Re: Final Report
Groundwater Budget and Approach to a Groundwater Management Plan,
Upper and Lower Ventura River Basin

Groundwater Budget and Approach to a Groundwater Management Plan Upper and Lower Ventura River Basin

Response to Comments

DRAFT Groundwater Budget and Approach to a Groundwater Management Plan, Upper and Lower Ventura River Basin (75% Complete), dated August 20, 2010

Figure 7a: Land Use, Upper Ventura River Subbasin. Land use coverage is shown for the Upper Ventura River Subbasin. [Sources: Southern California Association of Governments (SCAG) land use data, 2005, as cited in Tetra Tech, 2009; Subbasin boundaries from Tetra Tech, 2009]

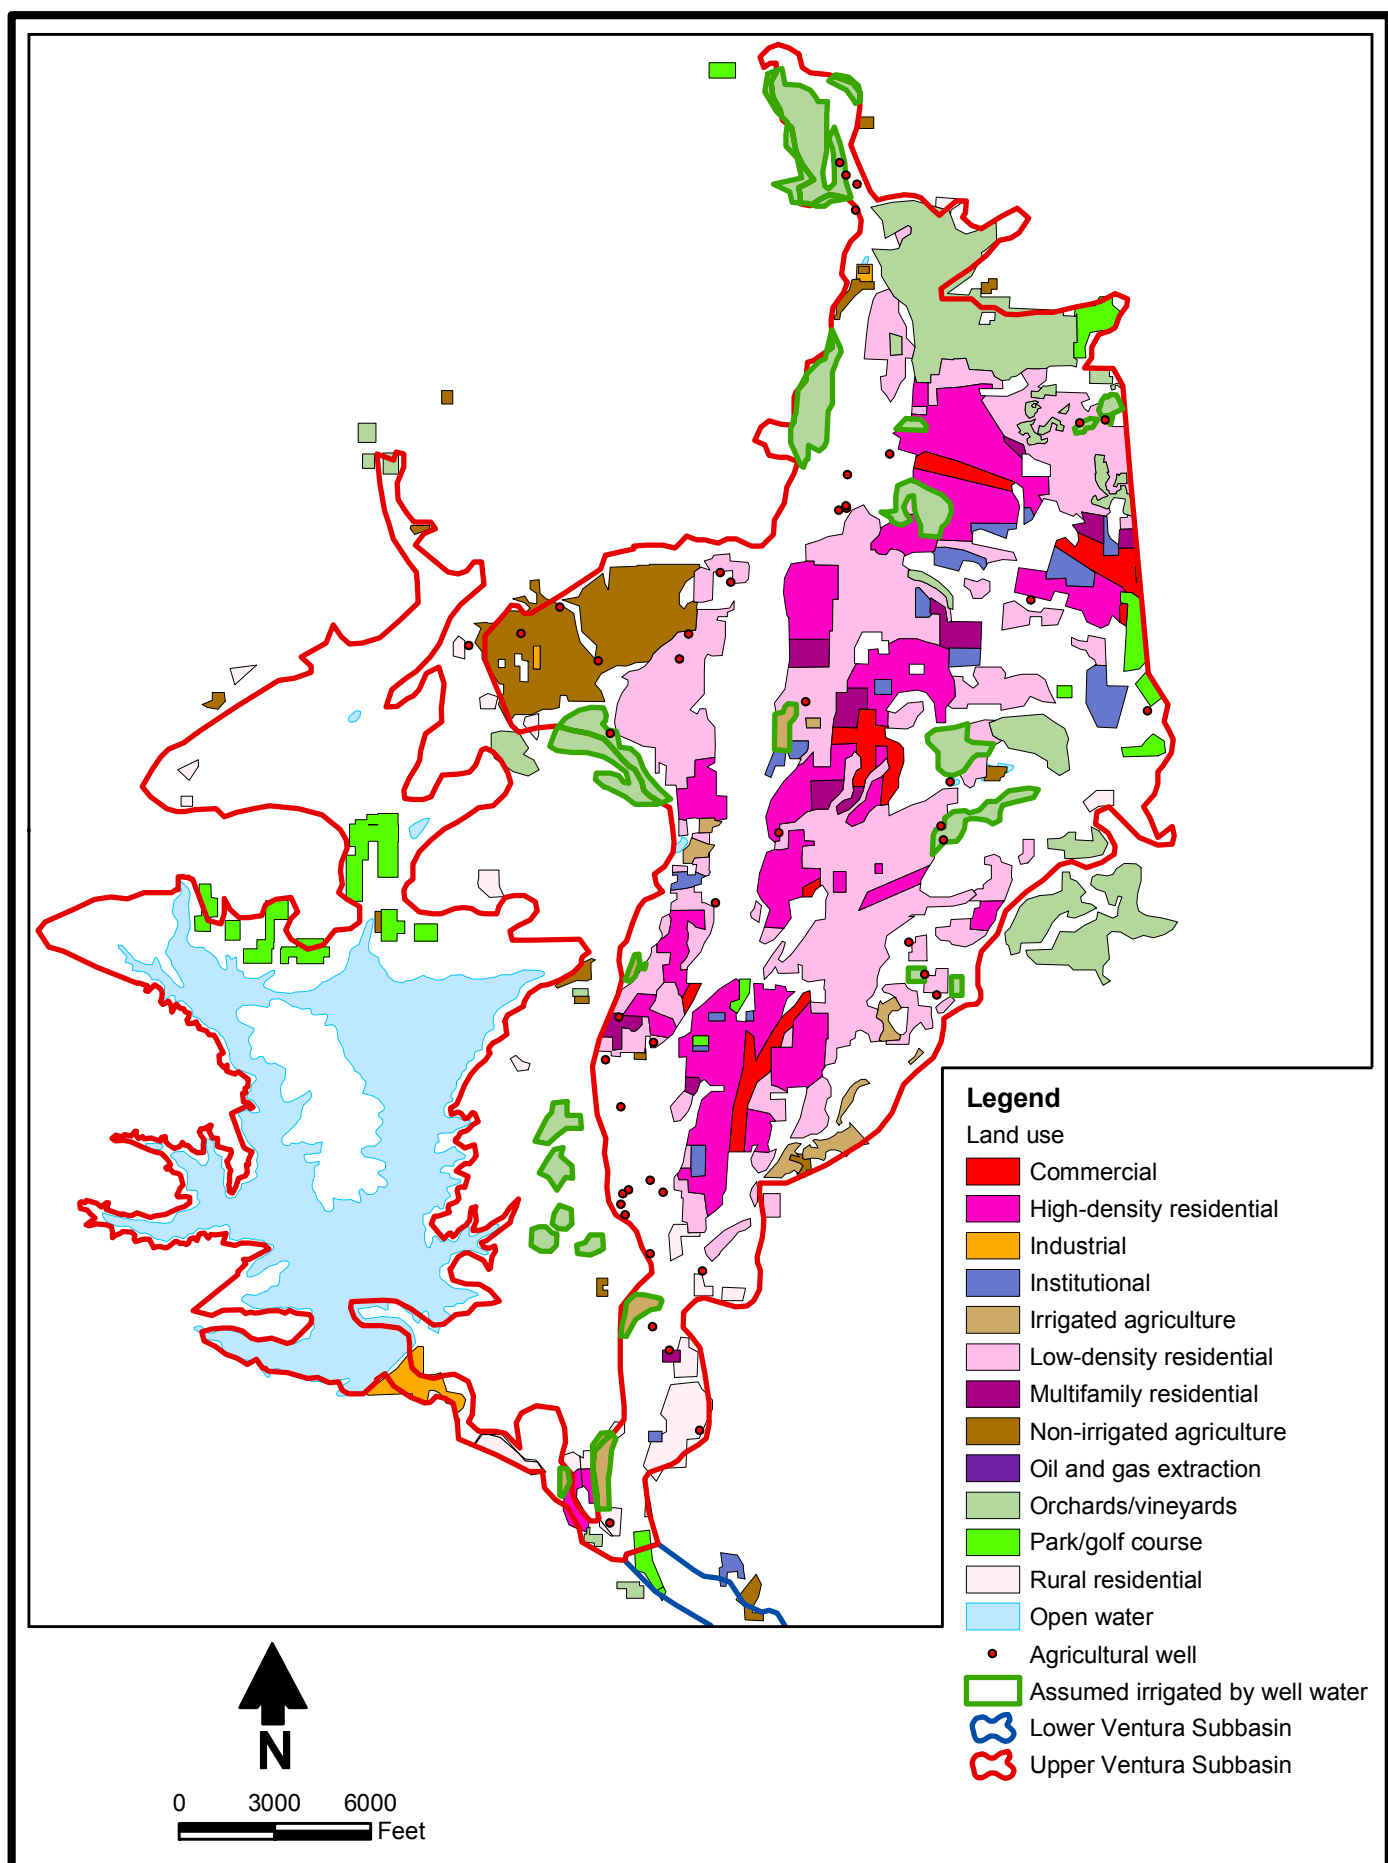
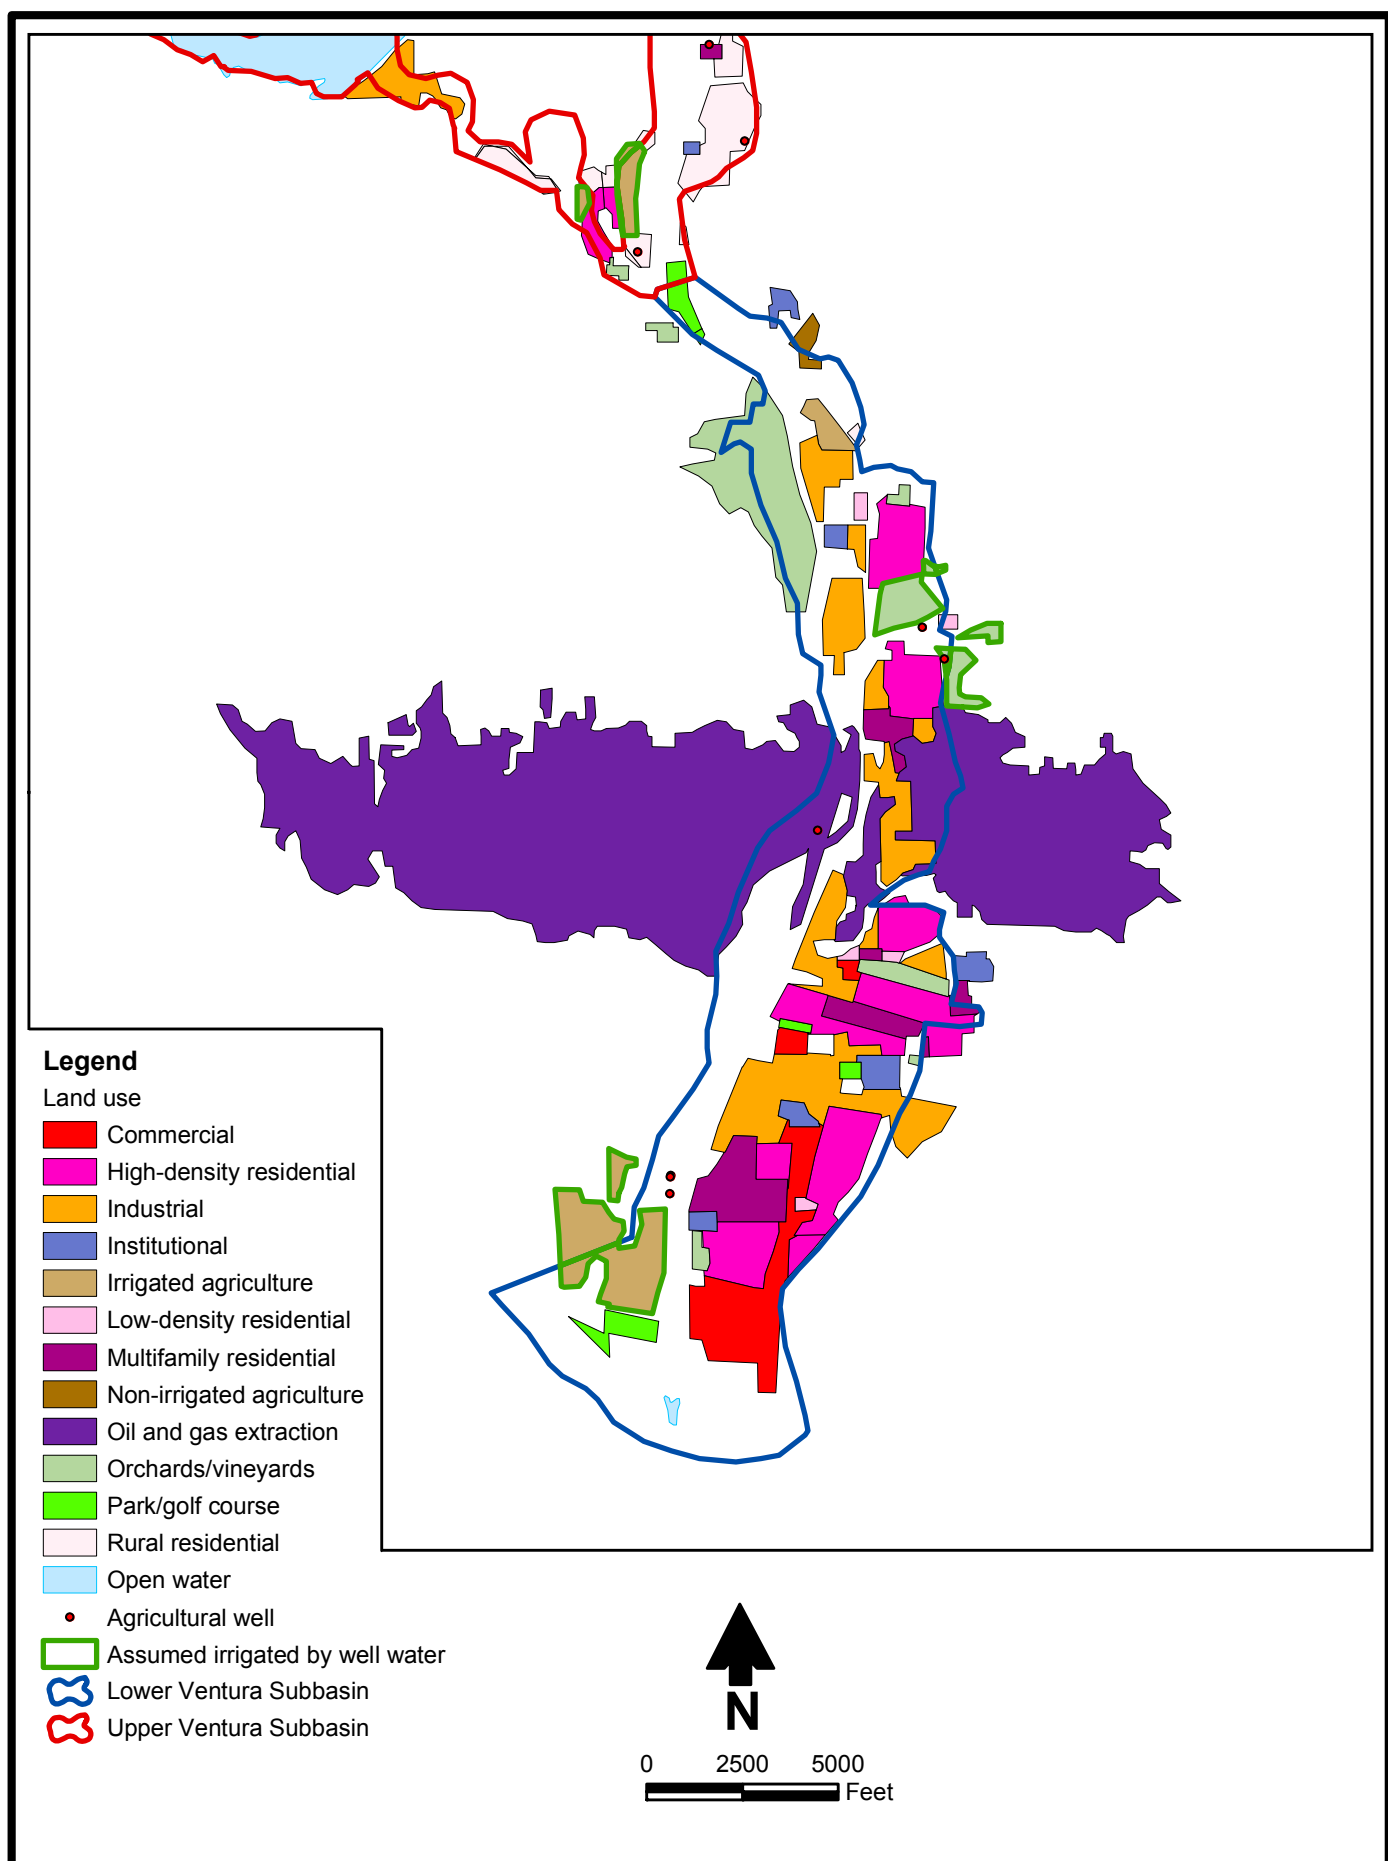
28. *Figure 5 - Same comment as for Figure 1. Please print map on larger page or split into basin map Upper and Lower on two pages. Also, please include time span or year covered by the land use information.*

This figure has been split into two parts as requested.

Figure 8: Parcel boundaries. Parcel boundaries are shown relative to the locations of the Subbasins. [Source: Parcel data, County of Ventura, http://gis.countyofventura.org/maps_data.htm; Subbasin boundaries from Tetra Tech, 2009]

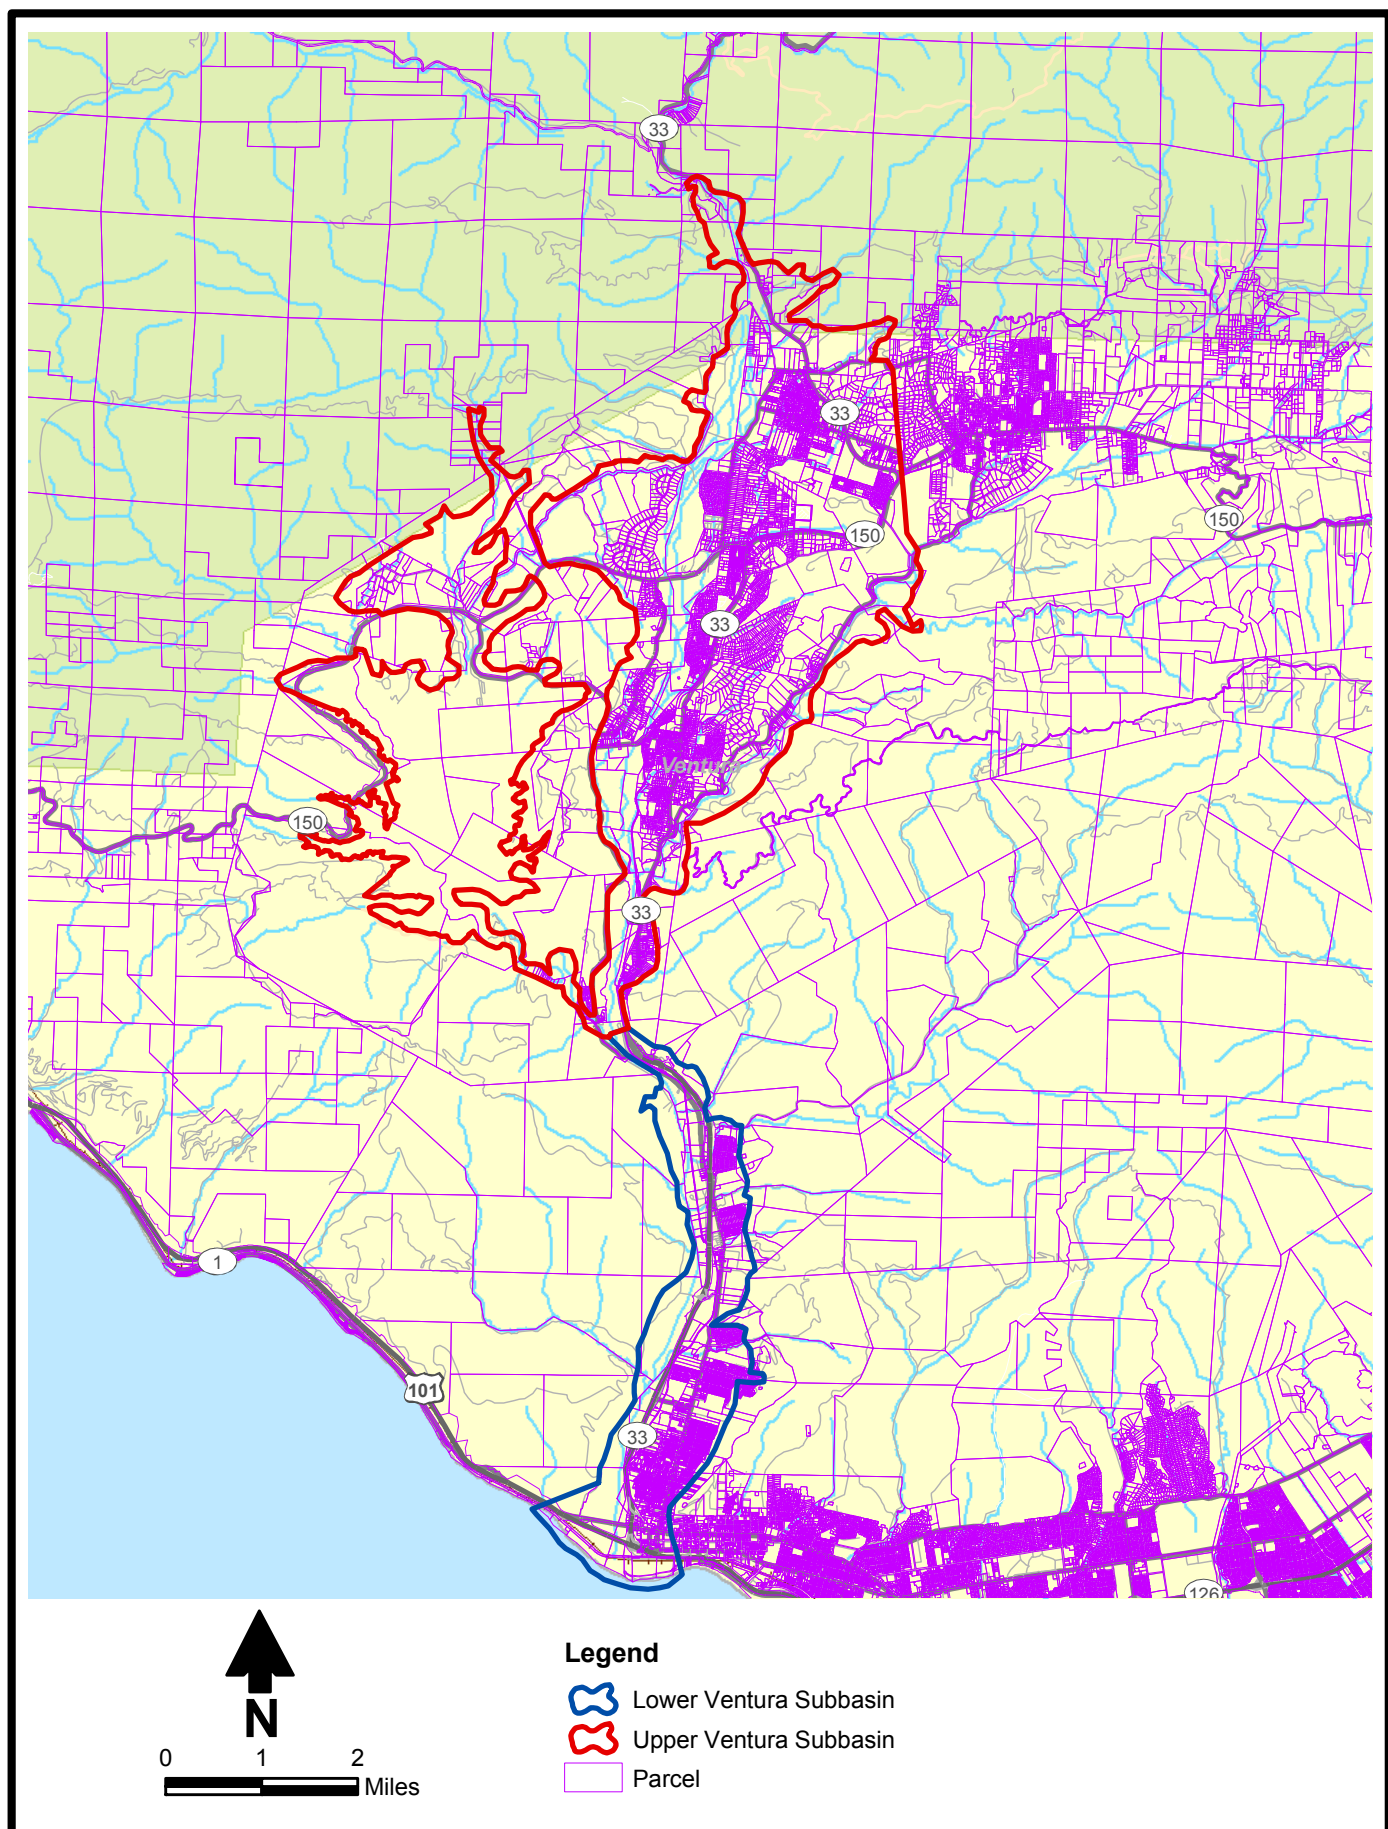
29. *Figure 6 - If possible indicate on the figure which parcels actually have septic systems.*

DBS&A is not able to include this information as the individual parcels are not discernable on the original figure.
